Re: *Addendum No. 2*
Jefferson WWTP Plant EQ Basin Improvements
Village of Jefferson

Date: February 13, 2026

GENERAL SITE AND PIPING PLAN	
SCALE:	1" = 20'
SHEET:	2 OF 13

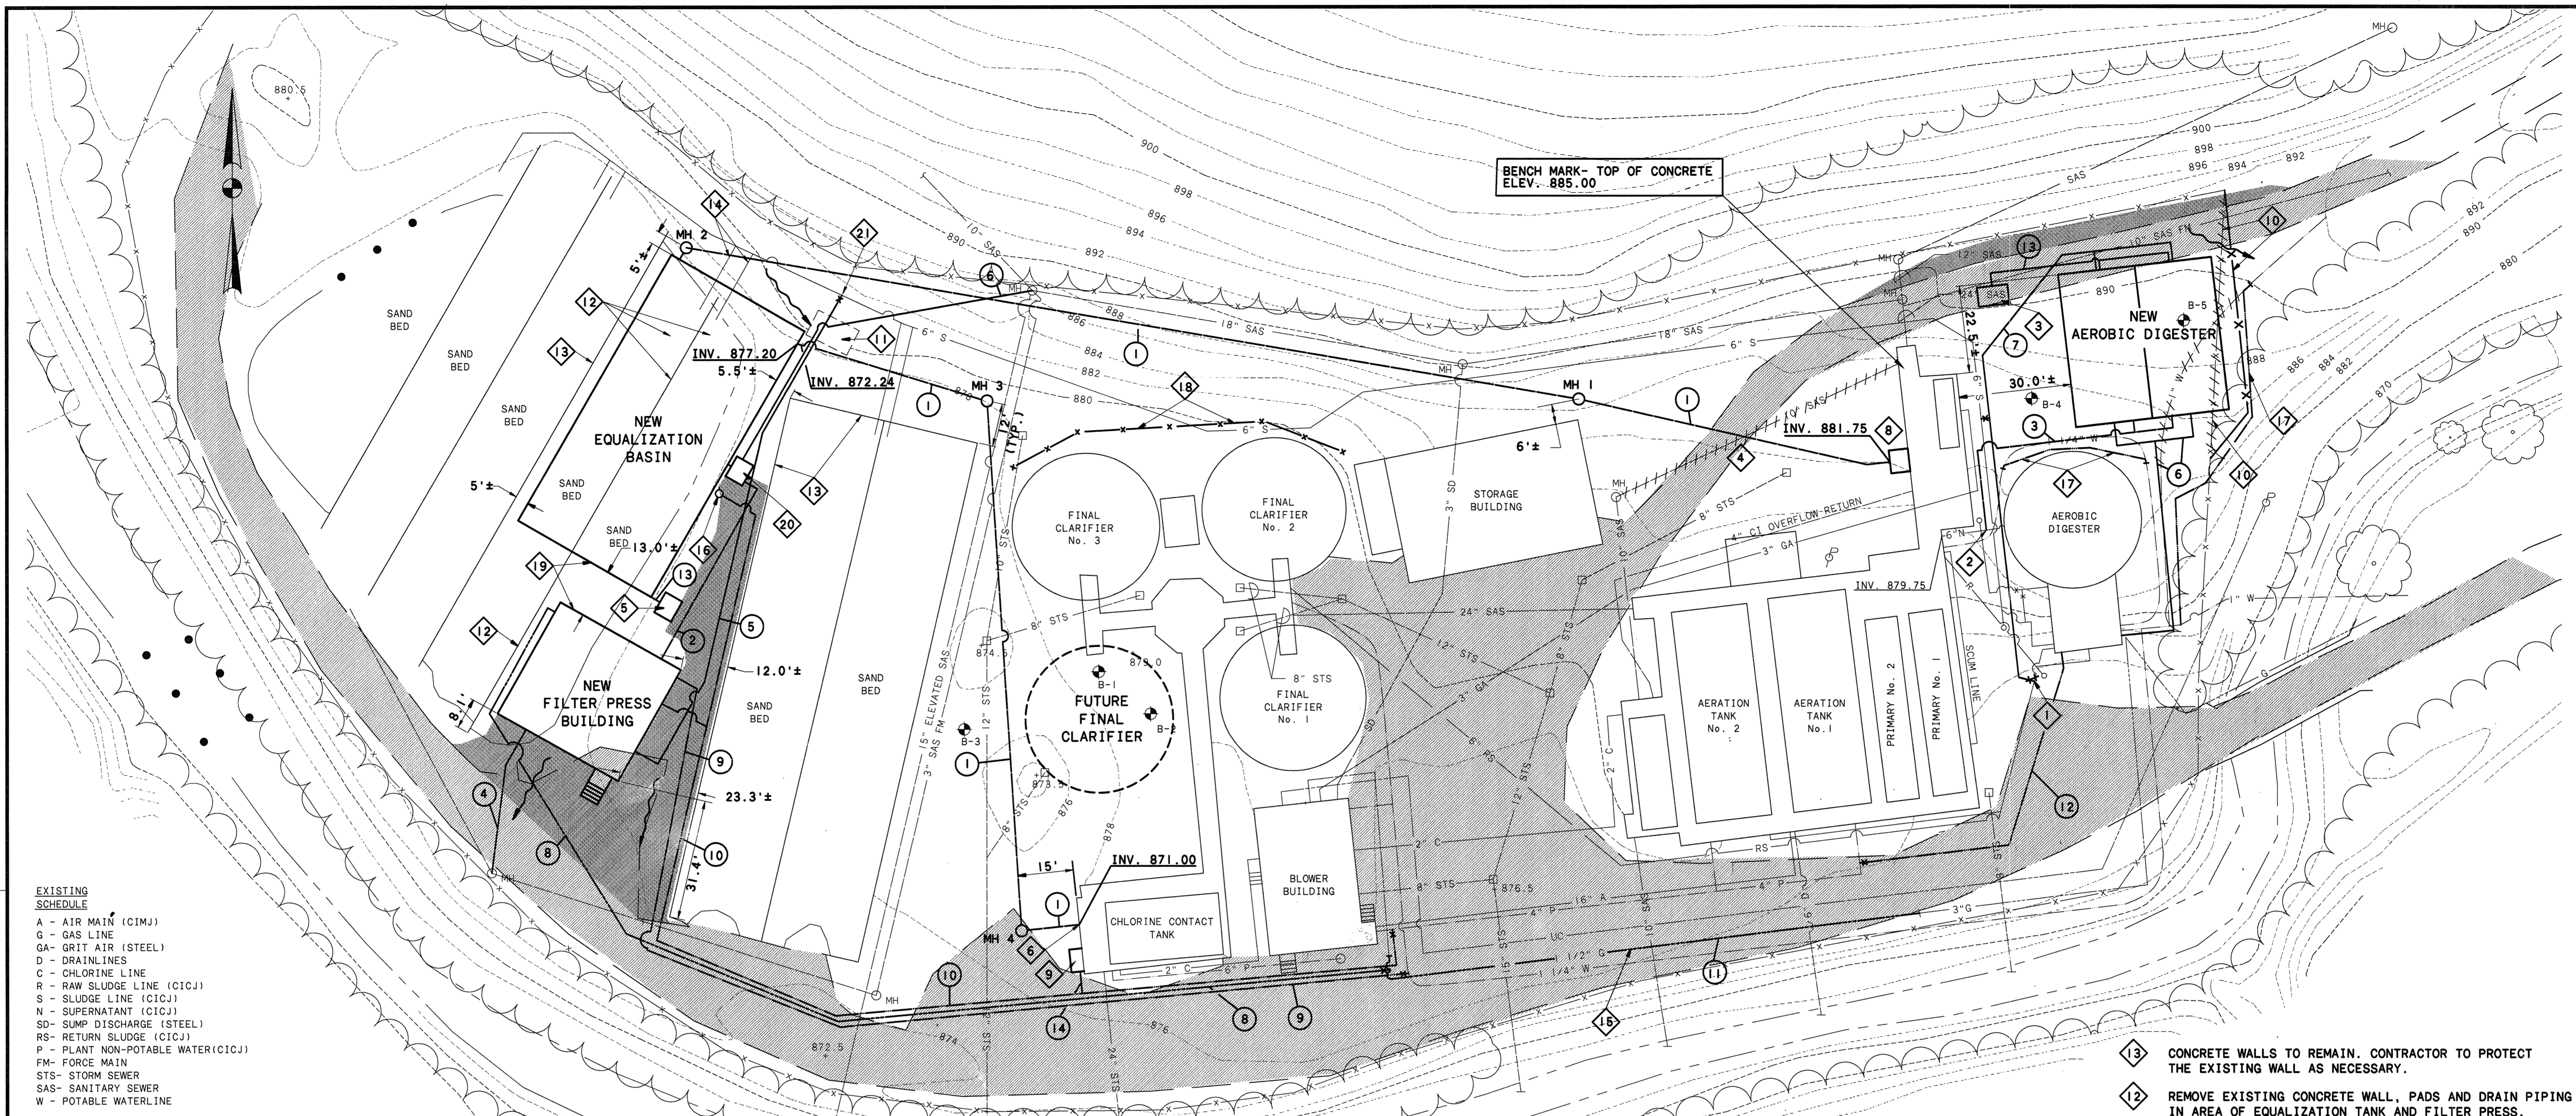
Q2. Are there any historical reference documents that show the piping plan for the full treatment plant.

A2. Yes, there is a historical site piping plan from the 1995 Expansion project enclosed for reference.
